# DEVELOPMENT REVIEW BOARD REPORT

**44-DR-2005**  
**Scottsdale Plaza**

Request approval of a site plan and elevations for an office, retail and restaurant building.

Elevations

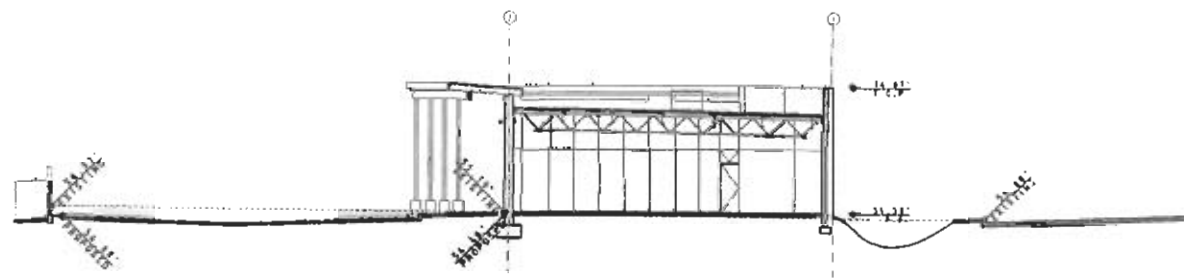
Staff approached the applicant regarding the building “turning its back to Thomas Road” architecturally, and suggested that modifications be made to make the project have a better street visage. The applicant responded by breaking up the solid wall façade with niches, and by adding trellis along the curve of the building where none was previously shown. The applicant also added additional detailing in the form of textured block.
